**LICENSE AMENDMENT REQUEST TO CHANGE TECHNICAL SPECIFICATIONS IN
SUPPORT OF PRNM / ARTS / MELLLA IMPLEMENTATION**

Columbia Generating Station Plant-Specific Responses
Required by NUMAC PRNM Retrofit Plus Option III Stability Trip Function Topical
Report (NEDC-32410P-A)

0000-0101-7647-R2
GEH DRF 0000-0098-4294
Class III
April 2010

Plant-Specific Responses Required By NUMAC PRNM
Retrofit Plus
Option III Stability Trip Function
Topical Report (NEDC-32410P-A)

Figure 1-1 MELLLA Operating Range Power/Flow Map

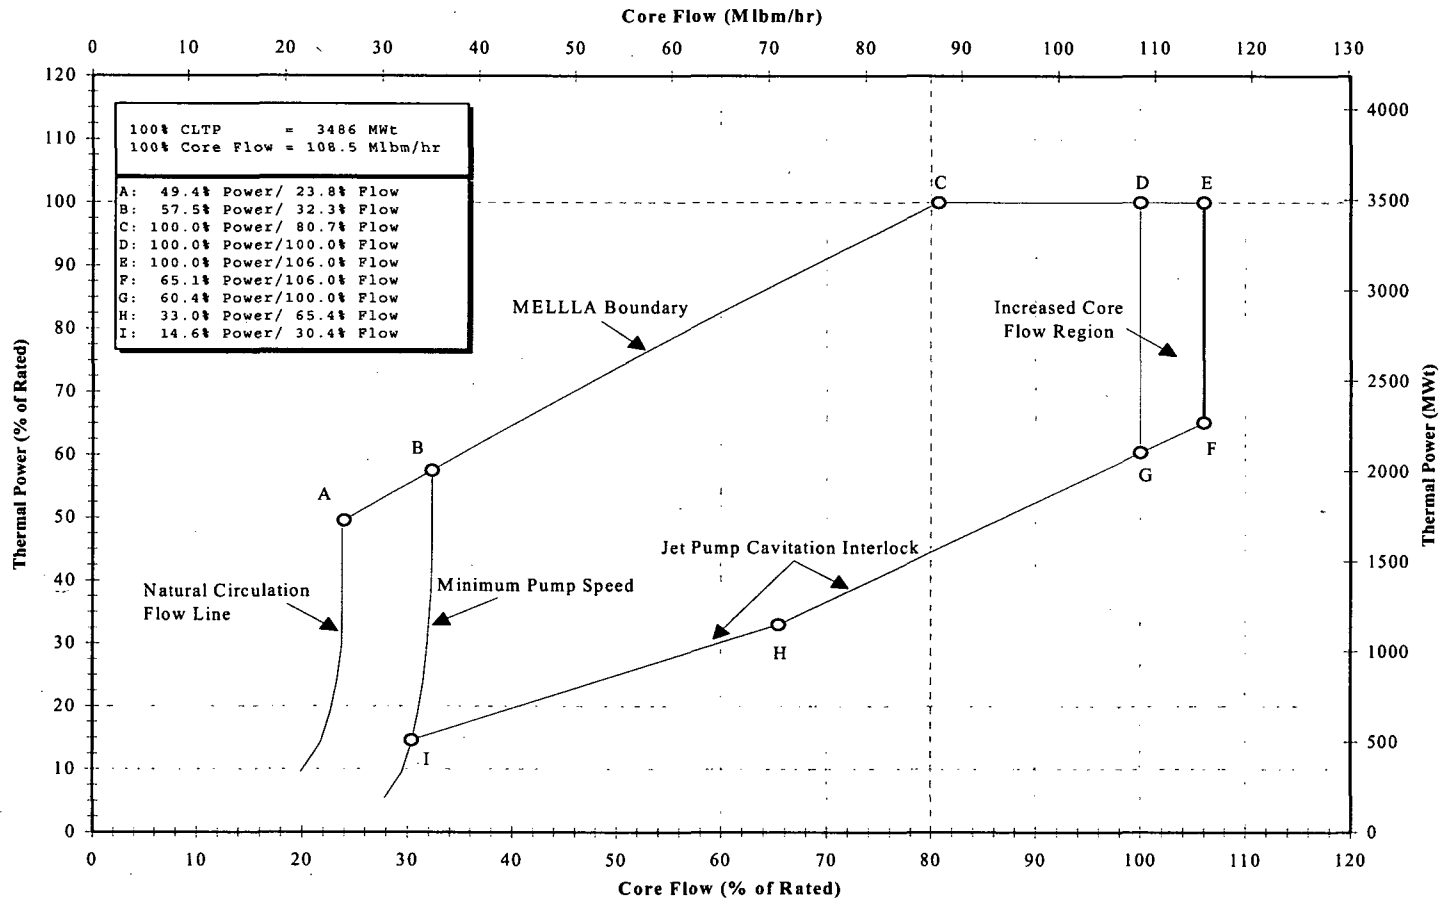
The current Extended Load Line Limit Analysis (ELLLA) P/F upper boundary is being modified to include the operating region bounded by the rod line which passes through the 100% of current licensed thermal power (CLTP) / 80.7% of rated core flow (RCF) point, the rated thermal power (RTP) line, and the rated load line, as shown in Figure 1-1. The P/F region shown in Figure 1-1 above the current ELLLA boundary is referred to as the Maximum Extended Load Line Limit Analysis (MELLLA) region. The MELLLA expansion of the power-flow map provides improved operational flexibility by allowing operation at RTP with less than RCF.

The P/F operating map (Figure 1-1) includes operating domain changes for ARTS/MELLLA consistent with approved operating domain improvements for other BWRs. The CGS MELLLA operating domain is defined by the following upper boundary:

Figure 4-1 Conceptual Illustration of Current Flow-Dependent RBM System with AC/BD LPRM Assignment

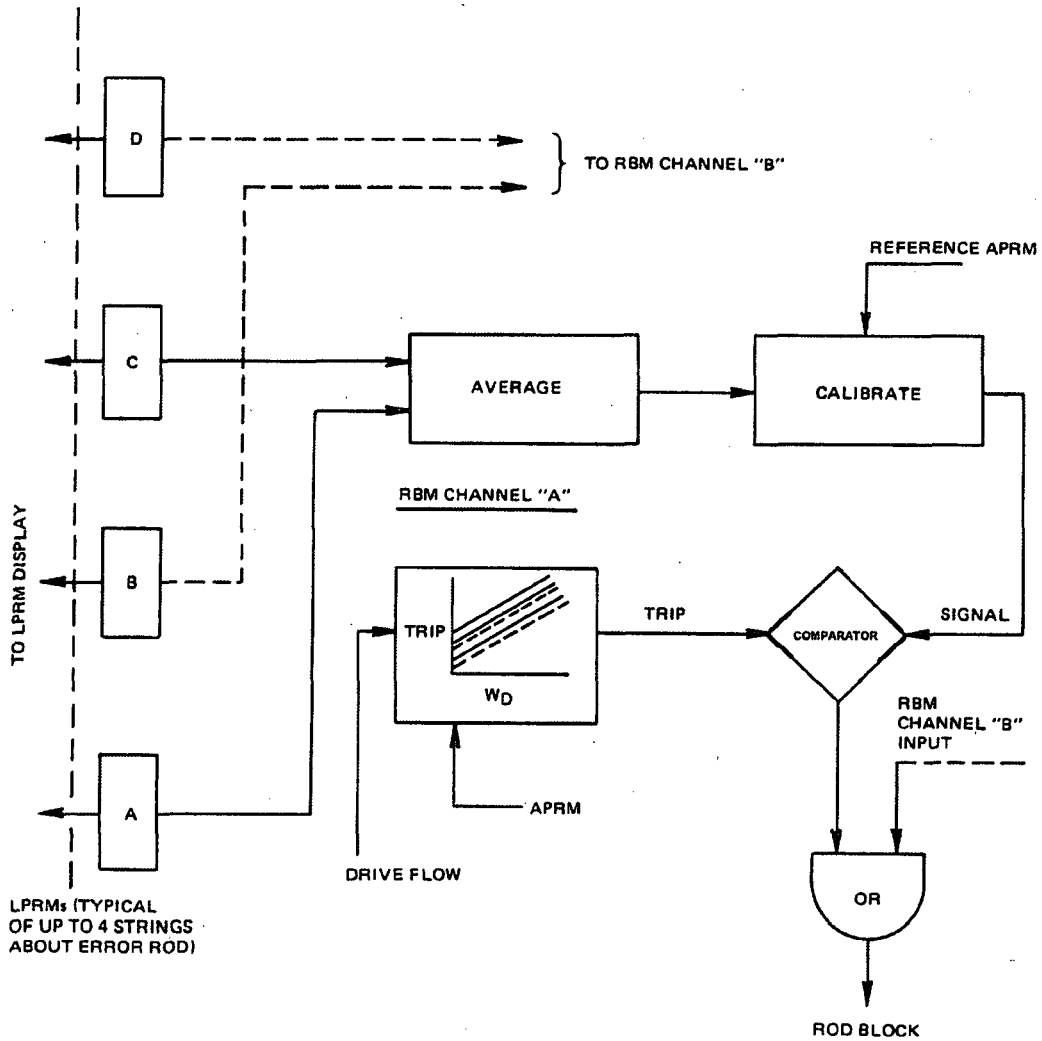
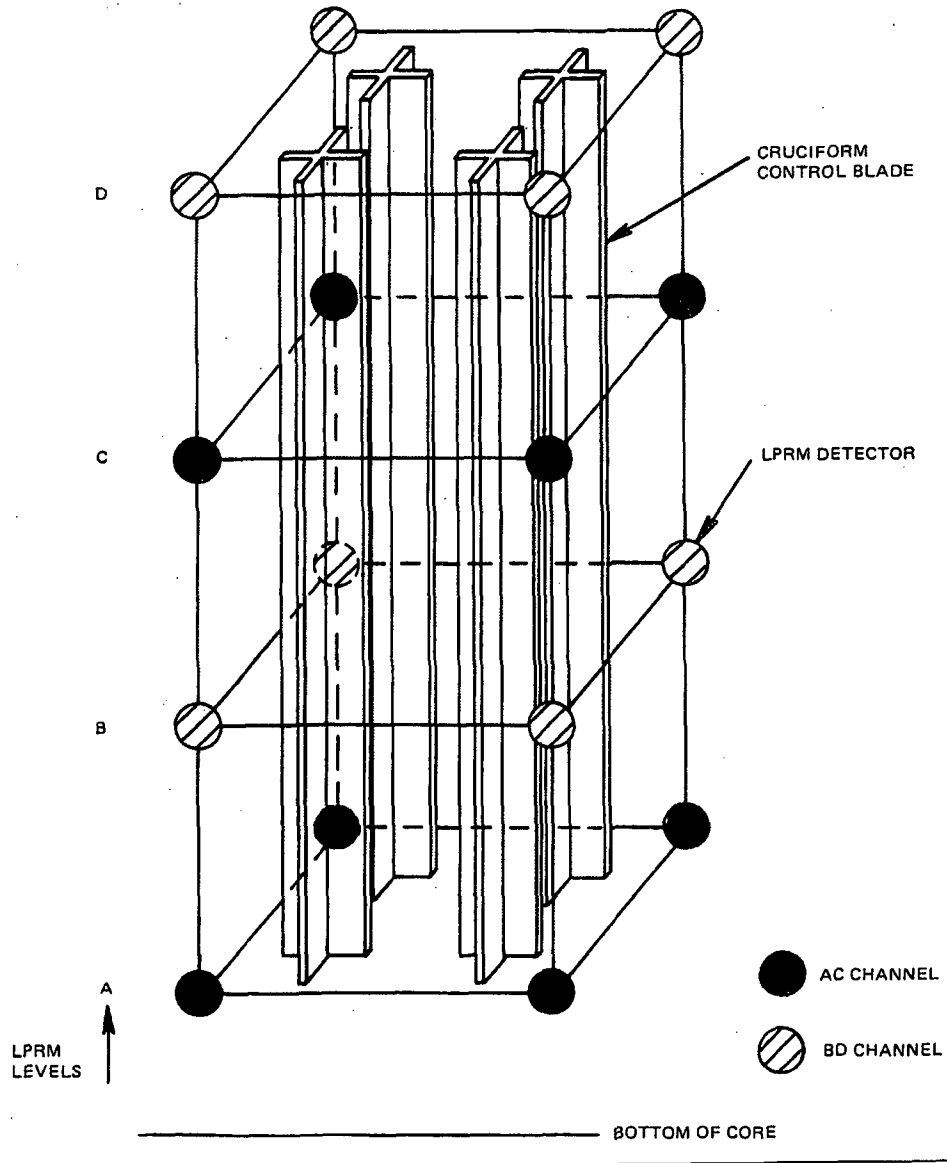
An illustration of the current CGS RBM system is presented in Figure 4-1.

The current selection of LPRM inputs that form the RBM signals (Figure 4-2) is not optimum for monitoring fuel integrity criteria because the two RBM channels have significantly different responses to the same control rod movement. For determination of RWE event consequences and the trip setpoints, the most responsive channel is assumed to be bypassed and the setpoints are determined by the operating (least responsive) channel. It is also assumed that some of the LPRMs assigned to the operating channel have failed. This further diminishes the response of this channel. The RBM setpoint chosen is the one that blocks rod withdrawal before violation of

Figure 4-4 New Power-Dependent RBM System with BCCD₁/BCCD₂ LPRM Assignment

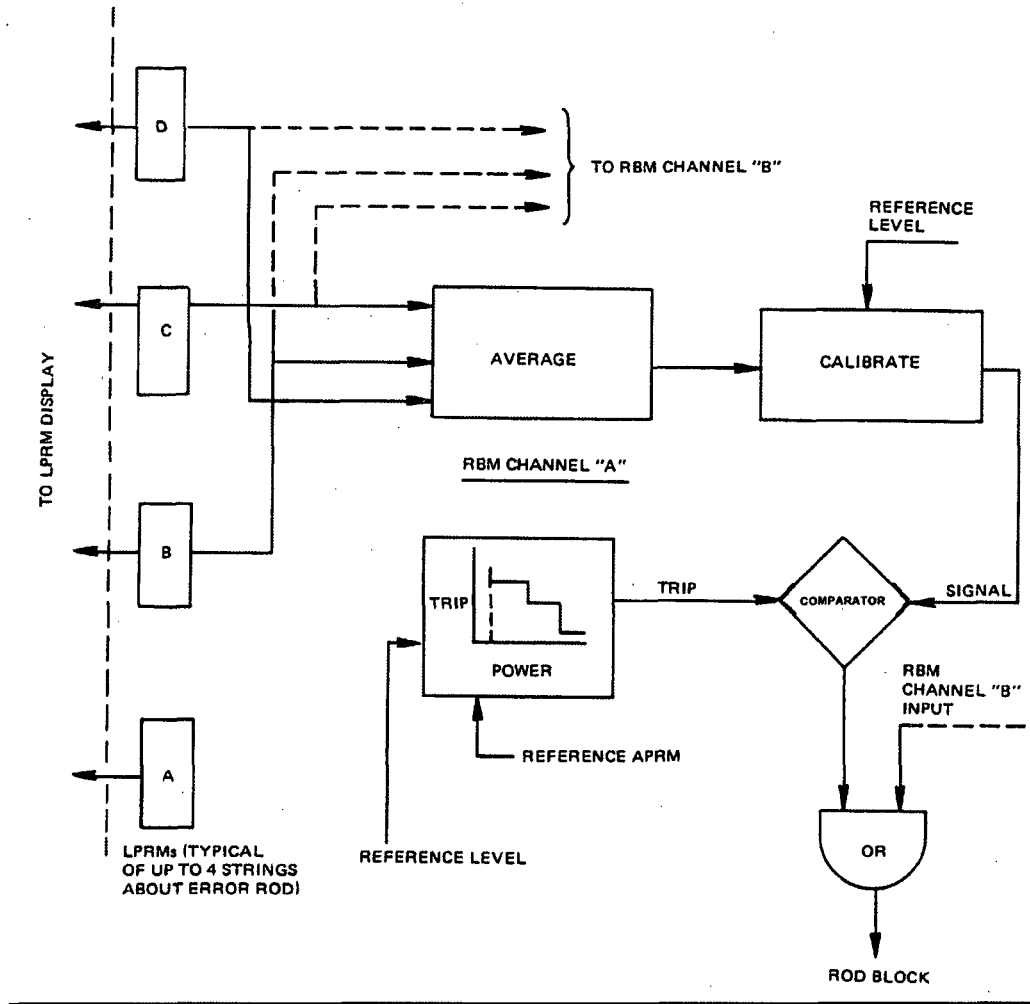
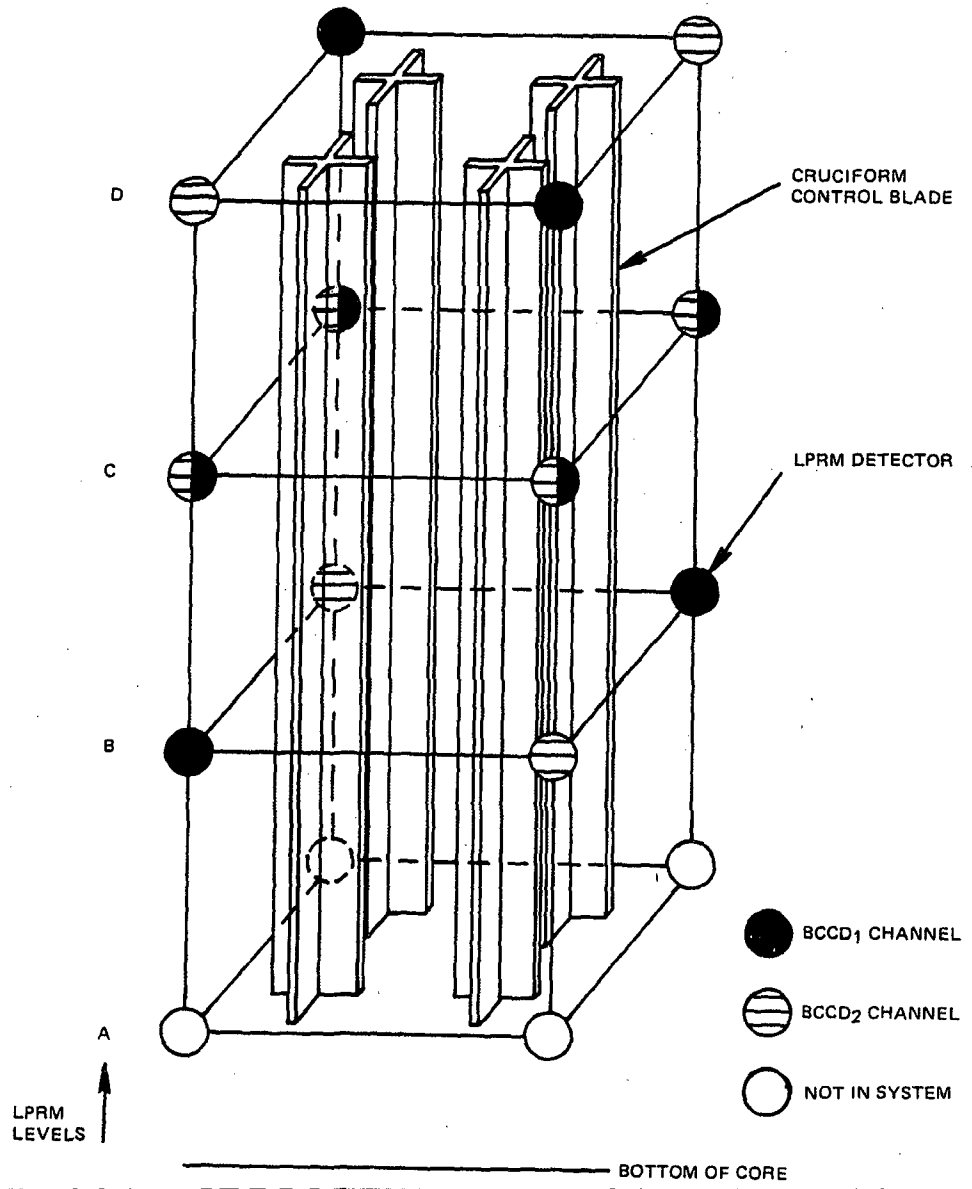
A more direct trip logic is implemented (Figure 4-4). Instead of calibrating to the APRM, the RBM signals are calibrated to a fixed (constant) reference signal. As in the original system, an RBM downscale trip level is defined to detect abnormally low signal levels. The upscale trip levels are set at a fixed level above the reference and will vary as step functions of core power. This will allow longer withdrawals at low powers where thermal margins are high and allow only short withdrawals at high power. Once tripped, recalibration is allowed only by deselecting the rod, typically accomplished by selecting another rod, and reselecting the rod. Reselection will result in a recalibration to the reference signal.

GEH studied a number of alternatives to the current LPRM assignment. Figure 4-2 illustrates the current LPRM assignments. The new assignment scheme (Figure 4-5) provides the best grouping to achieve the following objectives:

Figure 6-2 Demonstration of Proposed BSP Regions for NFWT

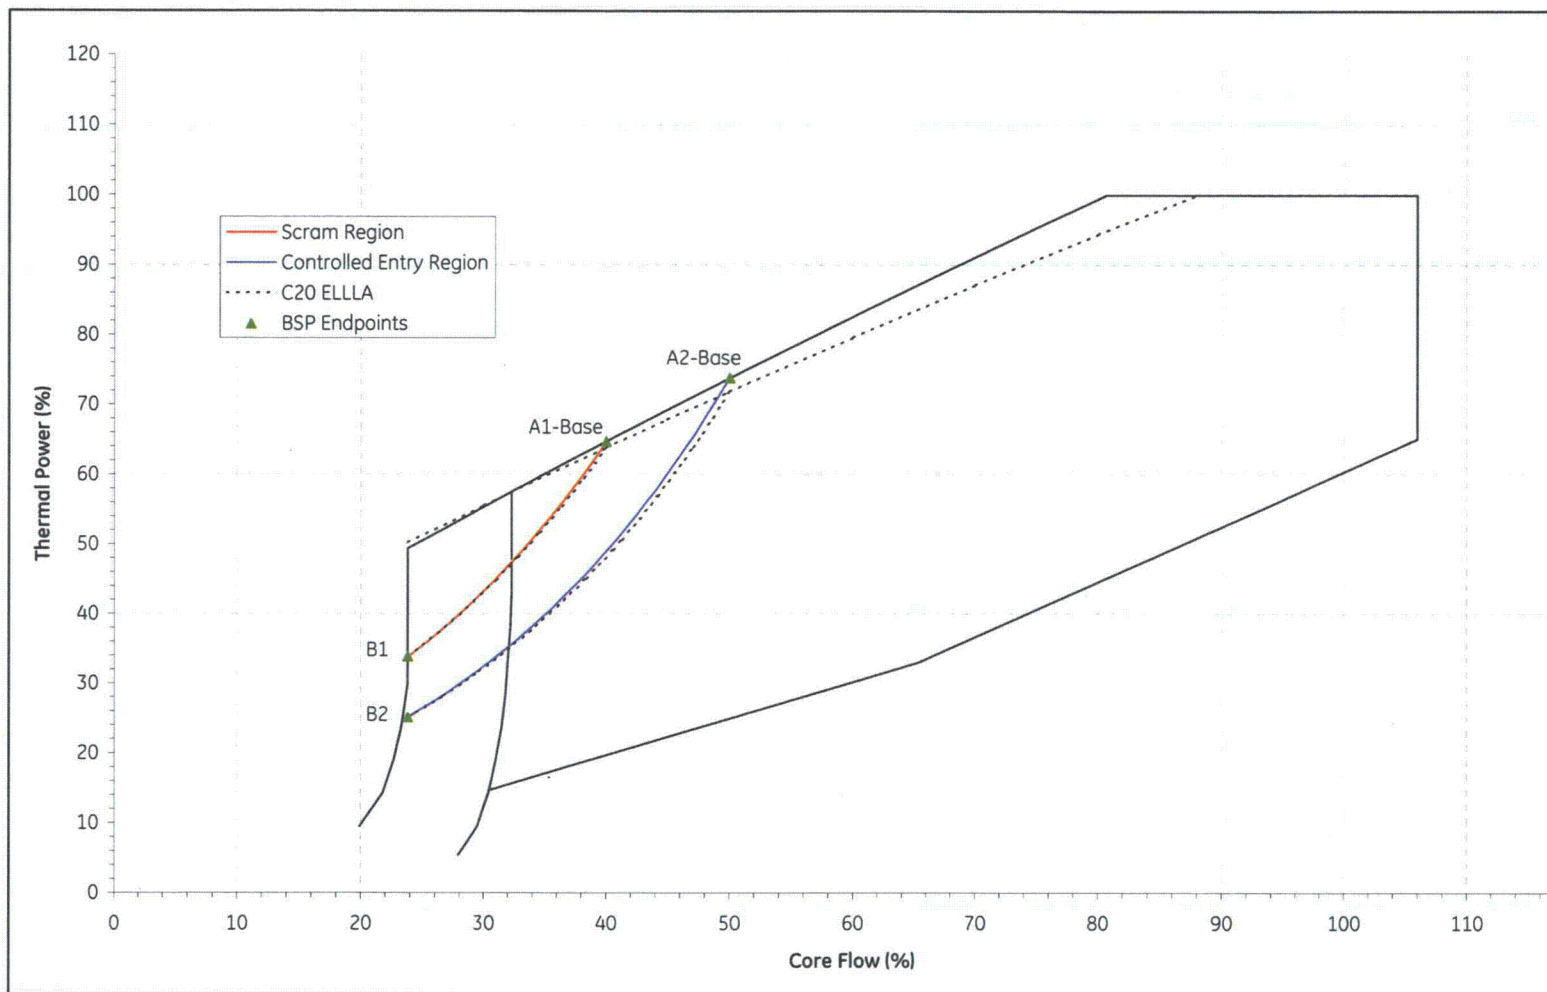
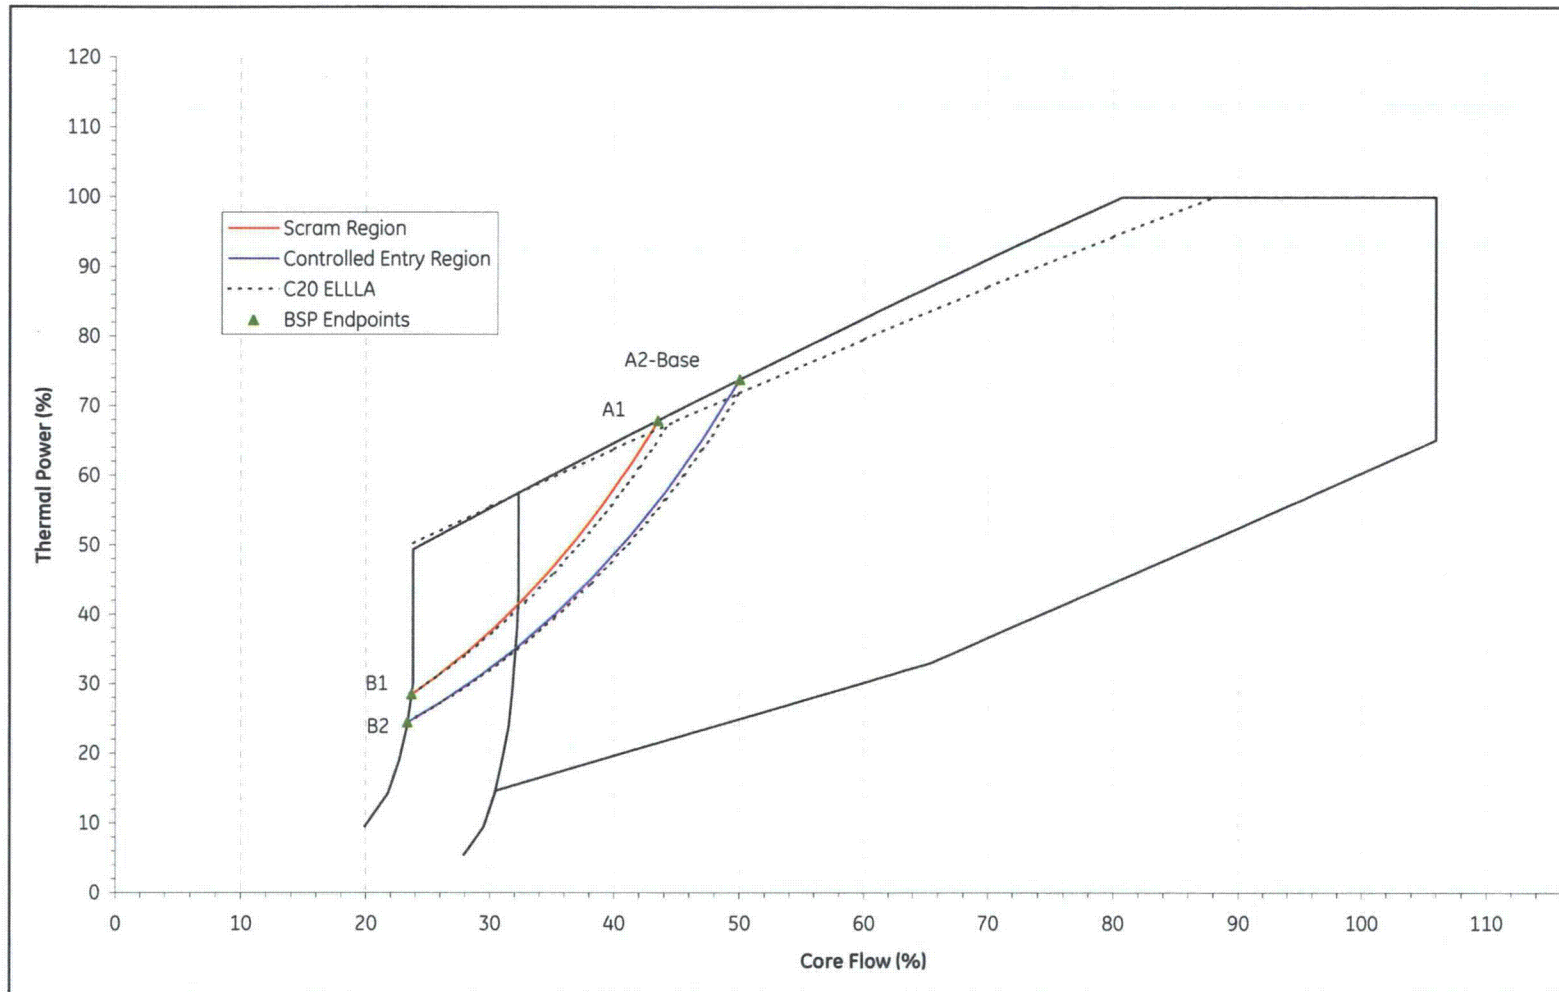
The demonstration BSP regions for both Nominal Feedwater Temperature (NFWT) and Reduced Feedwater Temperature (RFTW) were expanded in the MELLLA region in accordance with the guidance in Reference 15. The demonstration of the proposed BSP regions, based on Cycle 20, is shown in Table 6-2 for NFWT and Table 6-3 for RFTW. Plots of the BSP regions on the P/F map are shown in Figure 6-2 for NFWT and Figure 6-3 for RFTW. The BSP regions, as described in Reference 15, are confirmed or expanded on a cycle-specific basis.
